# SERVICE LETTER

No. 546A

Piper Aircraft Corporation  
(Supersedes Service Letter No. 546)

<u>Reason for Revision:</u>	Roll Pin part number change (reference Material Required, below. NOTE: Destroy all copies of Service Letter No. 546.
<u>Subject:</u>	Nose Gear Push-Pull Rod Assembly
<u>Models Affected:</u>	PA-24-180-250 and 400 Comanche
<u>Serial Numbers Affected:</u>	PA-24-180-250, Serial Nos. 24-1 to 24-3614 incl. PA-24-400, Serial Nos. 26-1 to 26-4 incl.
<u>Compliance Time:</u>	Recommended at the next 100 hour inspection.
<u>Purpose:</u>	To inspect the above referenced aircraft nose gear push-pull rod assembly, Piper part number 21109-00 and install a roll pin at each end of the subject rod assembly to supplement the weld.  NOTE: All part number 21109-00 nose gear push-pull rod assemblies purchased from the factory subsequent to December 31, 1964, are <u>not</u> affected by this publication.
<u>Instructions:</u>	<ol style="list-style-type: none"><li>1. It will be necessary to reinforce the subject rod assembly by installing a roll pin near each end of the rod; refer to sketch on reverse side for roll pin installation instructions.</li><li>2. If inspection reveals any slippag

SKETCH "A"

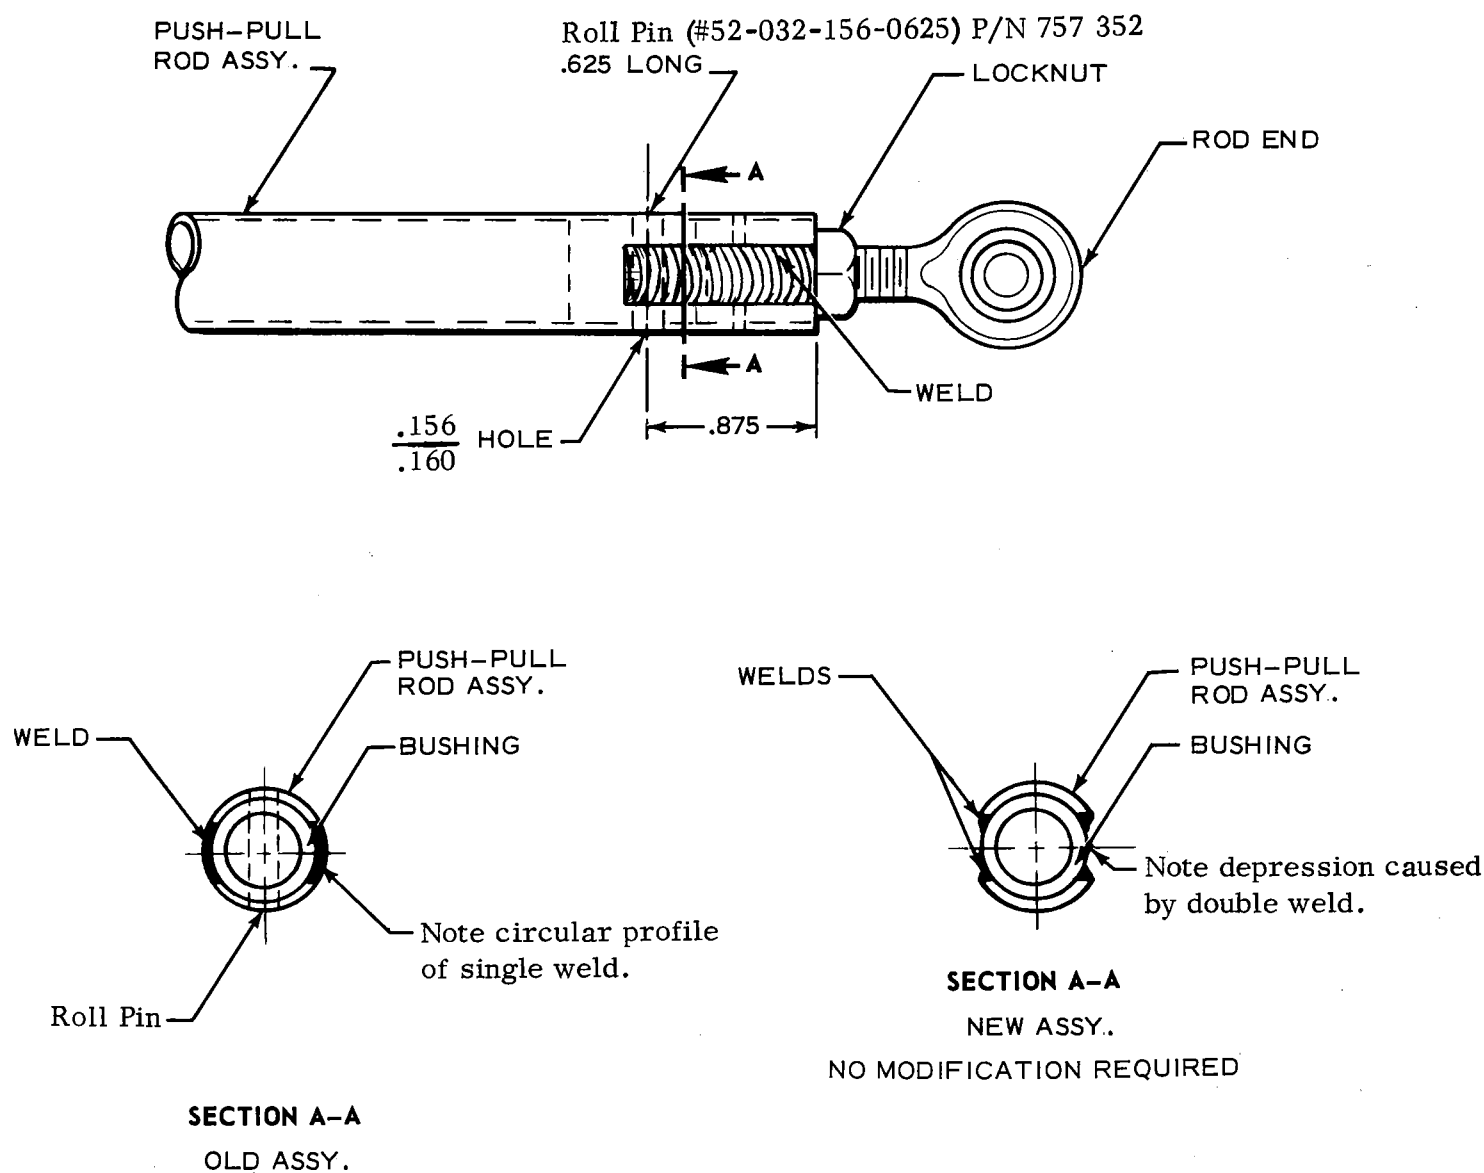
Note: If any doubt exists as to the type of weld (old or new) on the subject rod assembly, roll pins should be installed.

b. Measure .875 of an inch from each end of the rod assembly as shown in Sketch A.

c. Drill a  $\frac{.156}{.160}$  inch hole through the rod and bushing. A six inch drill bit is recommended.

Drilled hole must be perpendicular to the welds. It is necessary to maintain the .875 inch dimension and the hole through the center of the rod assembly as shown in Sketch A.

d. Insert roll pin, .625 inch long into the hole drilled in the rod assembly. Using 3/4" plastic type electricians tape, wrap rod assembly directly over the roll pin. Two turns are recommended. This tape will prevent moisture from entering roll pin center.
